## DEVELOPMENT APPLICATION ASSESSMENT REPORT

<b>Application Number:</b>	DA2022/0574
----------------------------	-------------

<b>Responsible Officer:</b>	Dean Pattalis
<b>Land to be developed (Address):</b>	Lot 20 DP 9877, 26 Walworth Avenue NEWPORT NSW 2106
<b>Proposed Development:</b>	Alterations and additions to a dwelling house
<b>Zoning:</b>	R2 Low Density Residential
<b>Development Permissible:</b>	Yes
<b>Existing Use Rights:</b>	No
<b>Consent Authority:</b>	Northern Beaches Council
<b>Land and Environment Court Action:</b>	No
<b>Owner:</b>	William Andrew Inglis Sarah Louise Inglis
<b>Applicant:</b>	William Andrew Inglis Sarah Louise Inglis

#### **Figure 1: Building envelope encroachment**

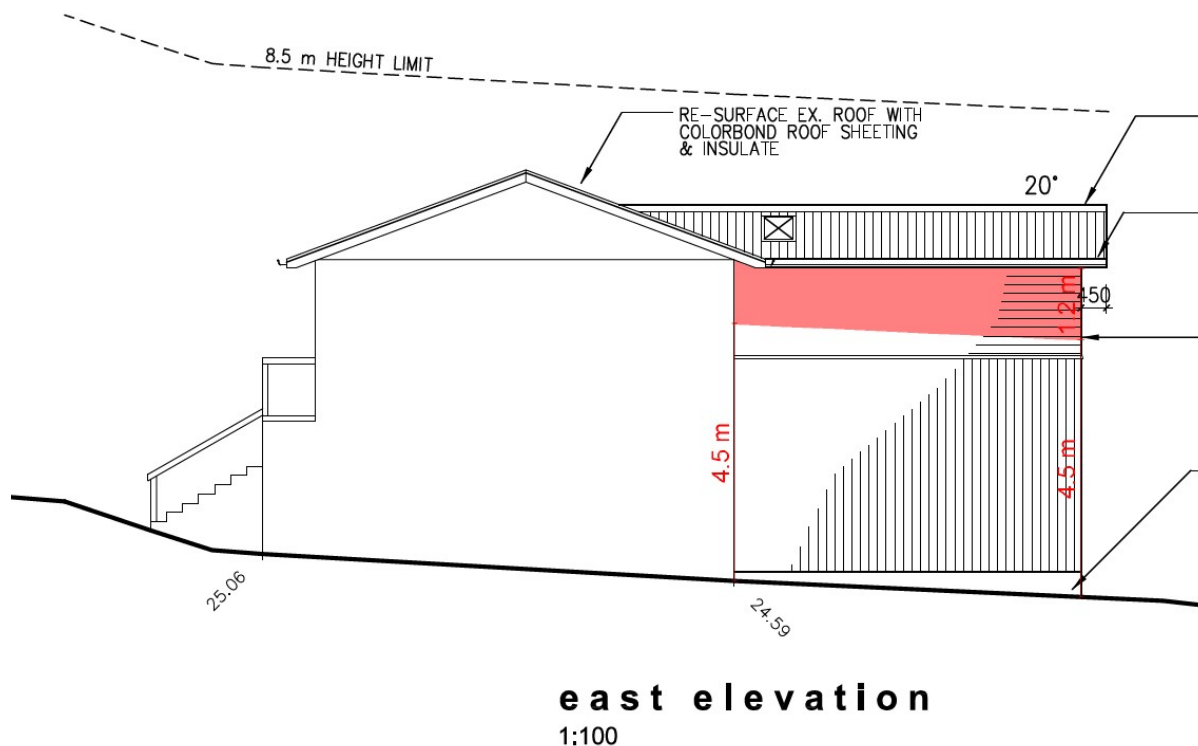
The proposed development encroaches the building envelope on the eastern side elevation by a maximum of 1.2m, representing a 26.7% variation to the numerical control (figure 1).

Having regard to the above assessment, it is concluded that the outcomes of the control have been achieved. Therefore, the application is supported on merit in this particular circumstance.
